APPEAL SUMMARY

Appeal ID: 24537	Project Address: 546 NE 12th Ave
Hearing Date: 1/20/21	Appellant Name: Joe Echeverri
Case No.: B-009	Appellant Phone: 9714201120
Appeal Type: Building	Plans Examiner/Inspector: John Cooley, Nate Takara
Project Type: commercial	Stories: 2 Occupancy: A-1, A-2, A-3, A-4, B, E Construction Type: II-B, III-B, II-A
Building/Business Name: Benson Polytechnic High School	Fire Sprinklers: Yes - NFPA 13 throughout
Appeal Involves: Erection of a new structure, Alteration of an existing structure, Reconsideration of appeal	LUR or Permit Application No.:
Plan Submitted Option: pdf [File 1] [File 2]	Proposed use: High School

Portland Public Schools
**BENSON
POLYTECHNIC
HIGH SCHOOL
MODERNIZATION**

546 NE 12th Ave, Portland, OR 97232

STAIR HANDRAIL
SECTIONS
ADMINISTRATION
SK 4

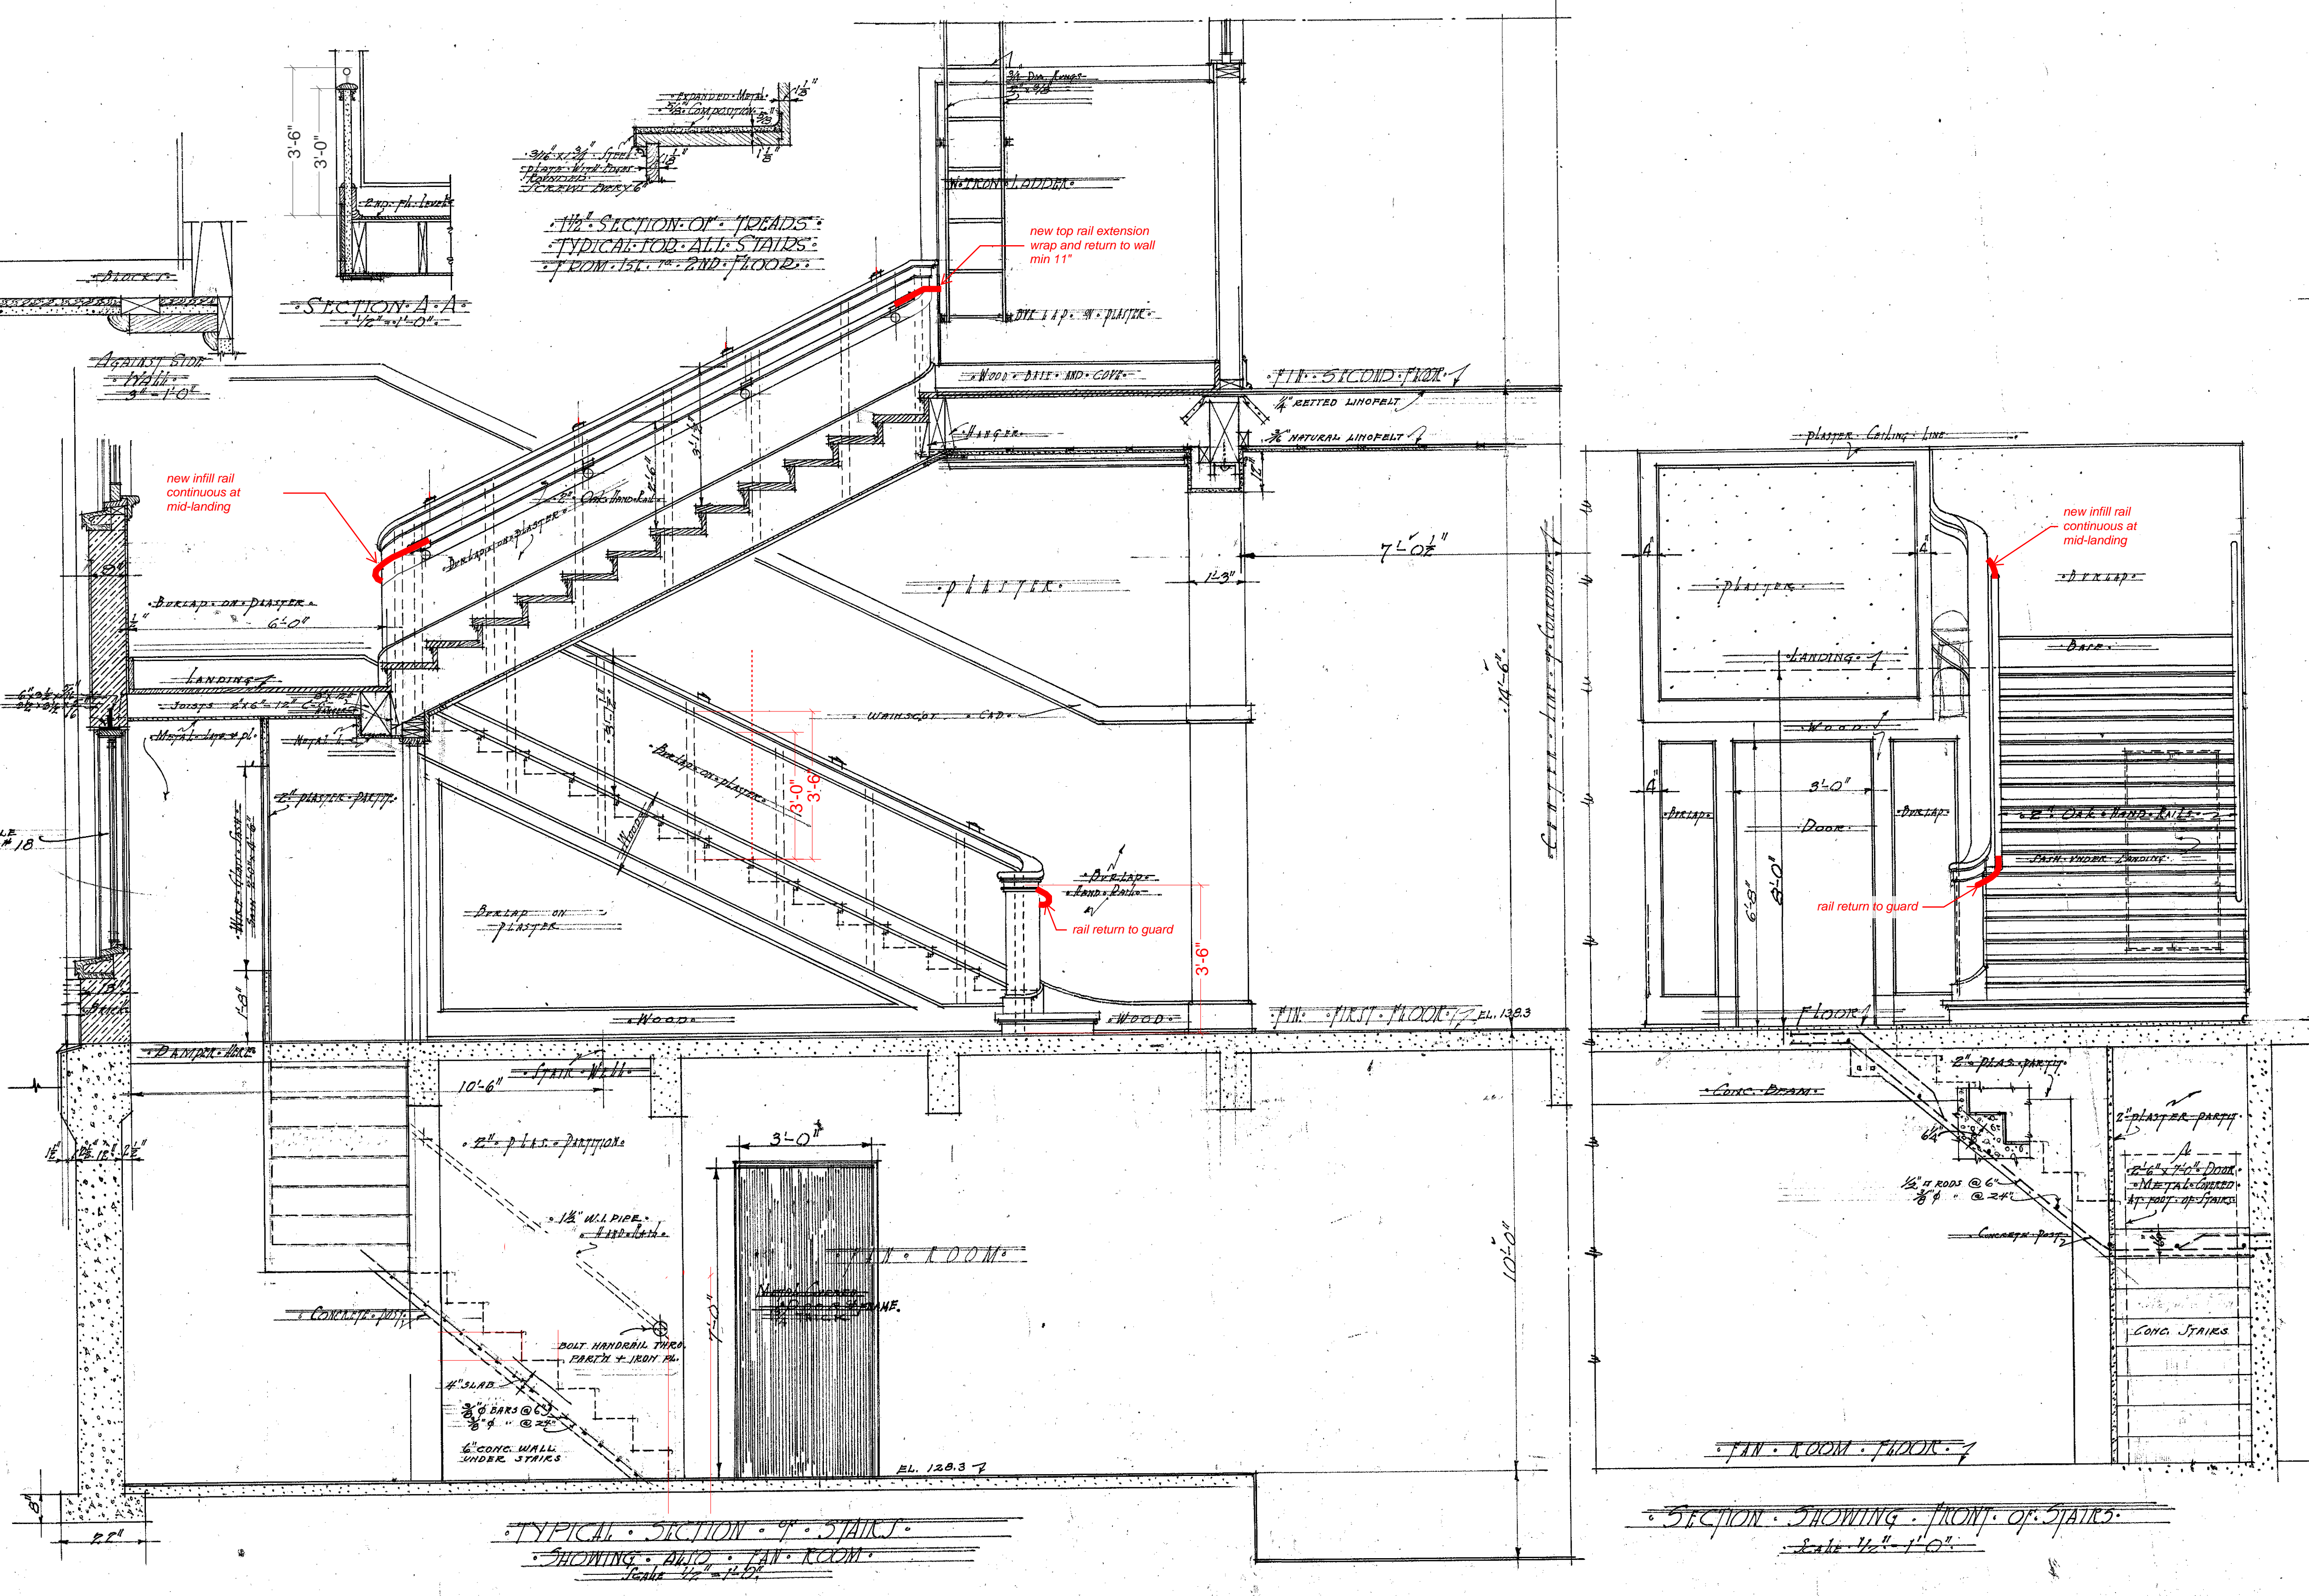
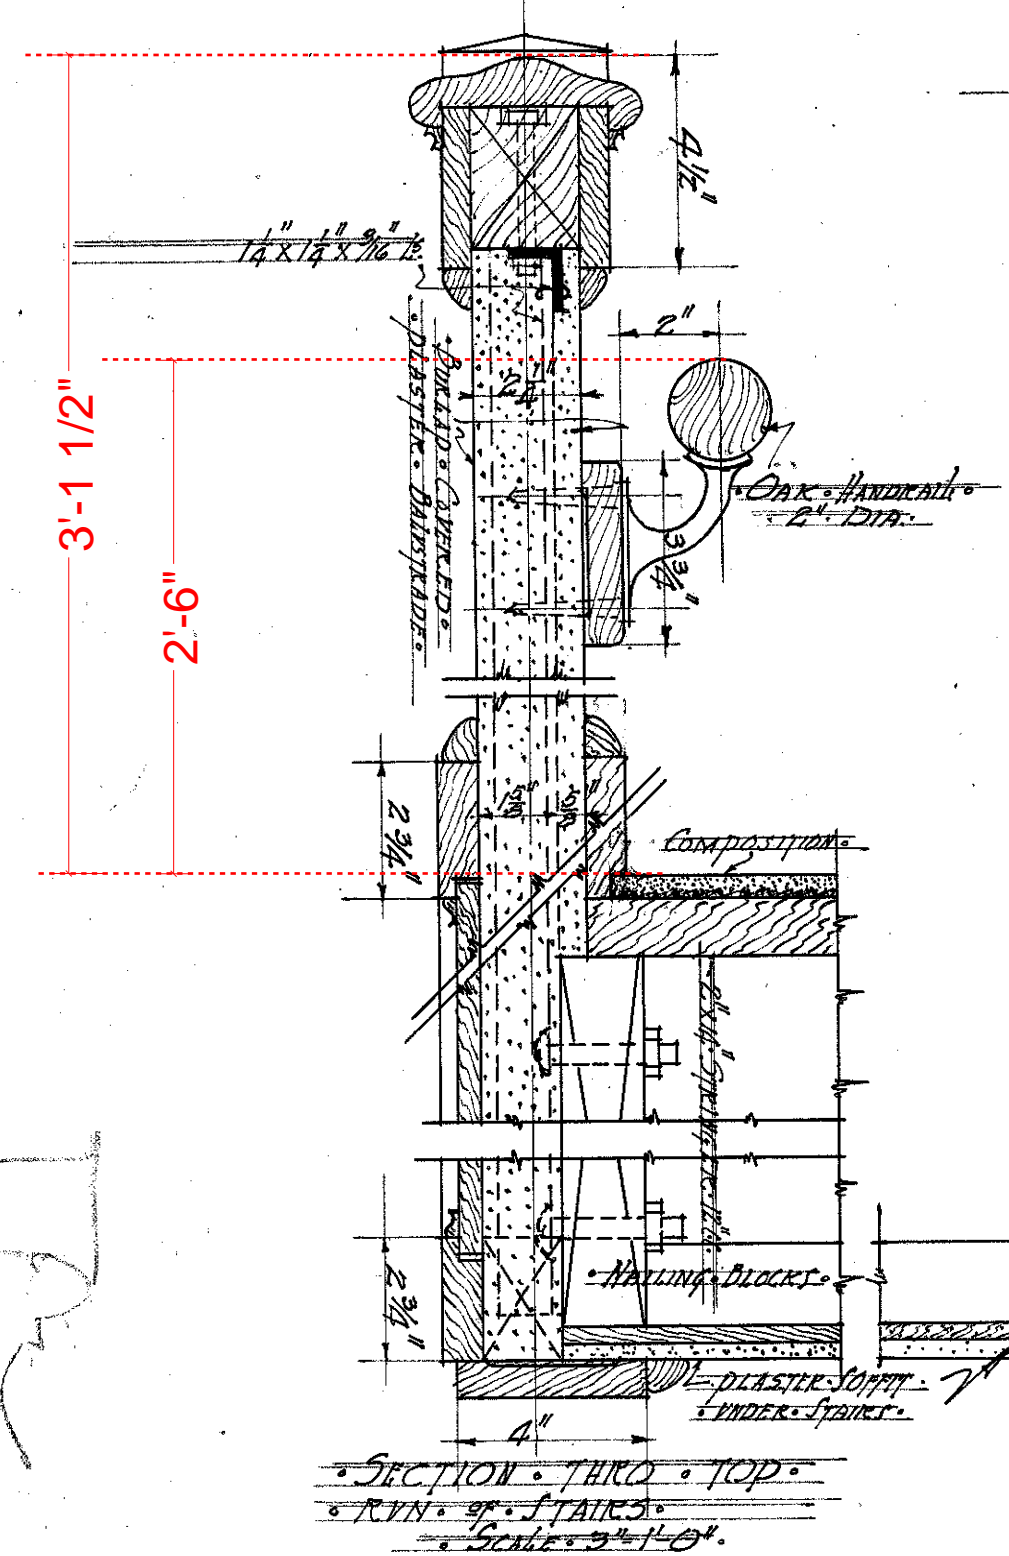
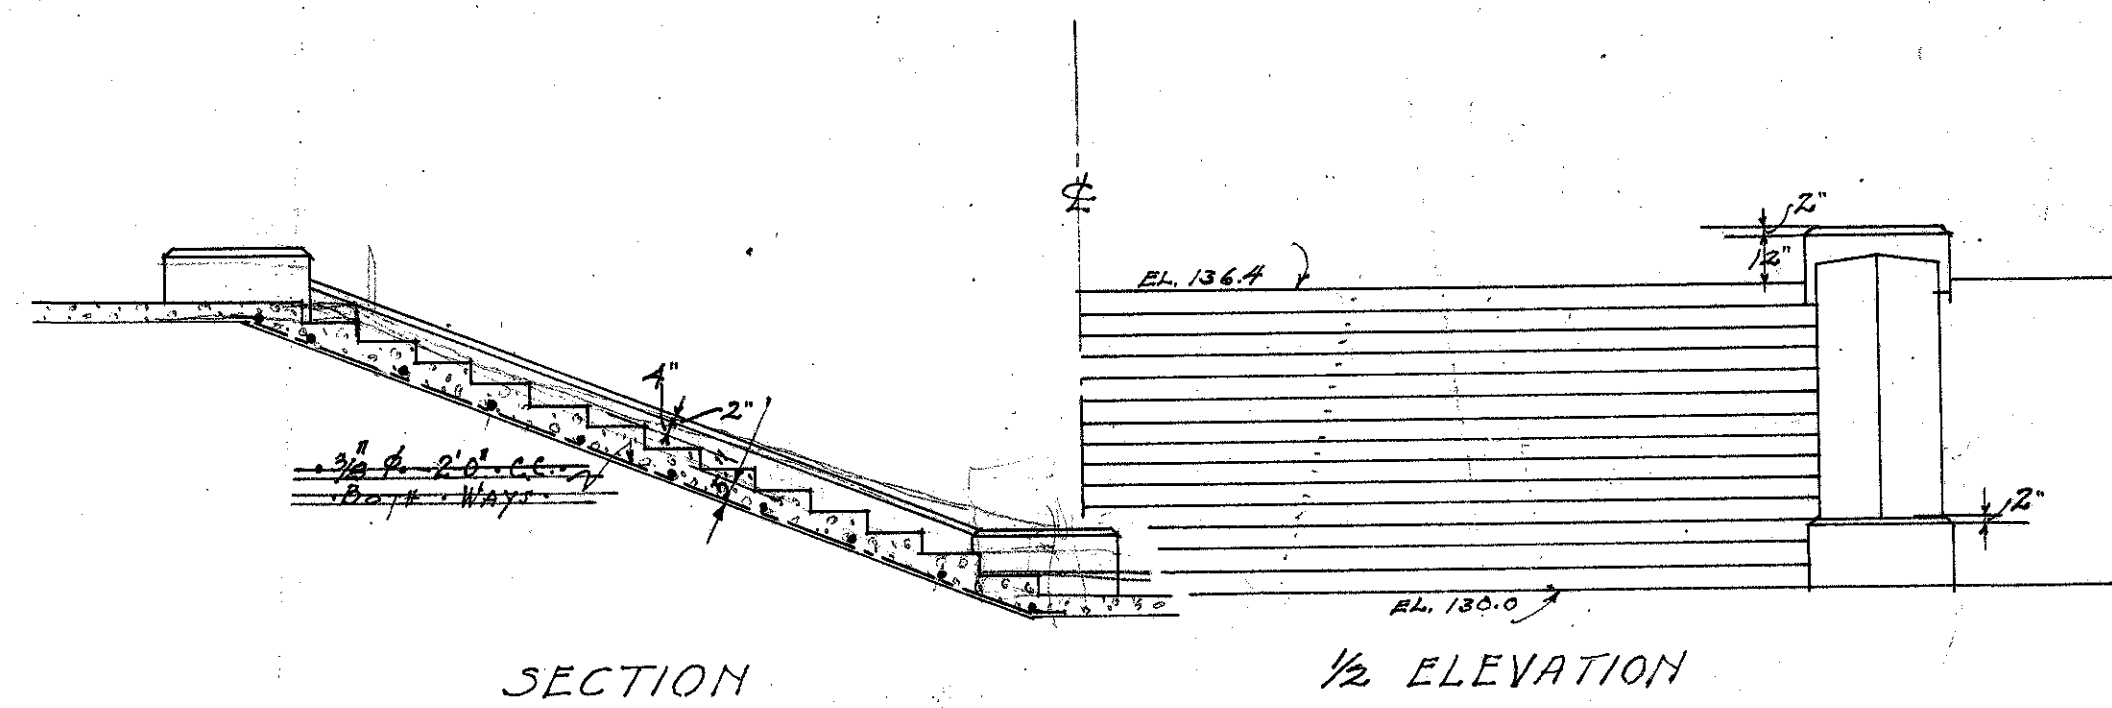
See exhibit pages SK2, SK3 and SK4 for rail heights, terminations, and continuity.

- Intermediate handrail height as-built 30" aff to remain.
- Install new perimeter wall handrail at 34 – 38" aff height.

- Intermediate handrail: Bottom terminate into guard less than 11". Top extend and wrap guard min 11"
- New perimeter wall handrail: Bottom and top extensions min 11" in direction of travel.

- Install tempered safety glazing at existing transom lights.
- Install quick response sprinkler heads within 12 inches of each side of glazed clerestory frame for water curtain coverage Levels 1 and 2.
- Level 2 hallway walls terminate at underside of ceiling as - built.

Locations: As indicated in initial appeal except Auditorium (Bldg. A) Delete Stair 4 guard. See SK2, SK3 and SK4 for historic building guard heights and details.

- 1. Reduction in minimum number of required plumbing fixtures: Granted as proposed.**
- 2. Existing handrail conditions to remain: Granted as proposed.**
- 3. Existing exit access stair configurations to remain with addition of quick response sprinkler heads: Granted as proposed.**
Note: Appeal also grants interior exit stairs 10 and 12 with quick response sprinkler protection on both sides of glazed walls. A separate permit from the Fire Marshal's Office is required.
- 4. Use of rail mounted ADA inclined platform stair lift for accessible route to two Level 2 classrooms at West side of Gymnasium: Granted as proposed with reduced stair width while lift is in operation.**
- 5. Omission of barrier where stairs continue below level of exit discharge: Granted as proposed.**
- 6. Allow existing historic guard rail heights to remain as built: Granted as proposed.**
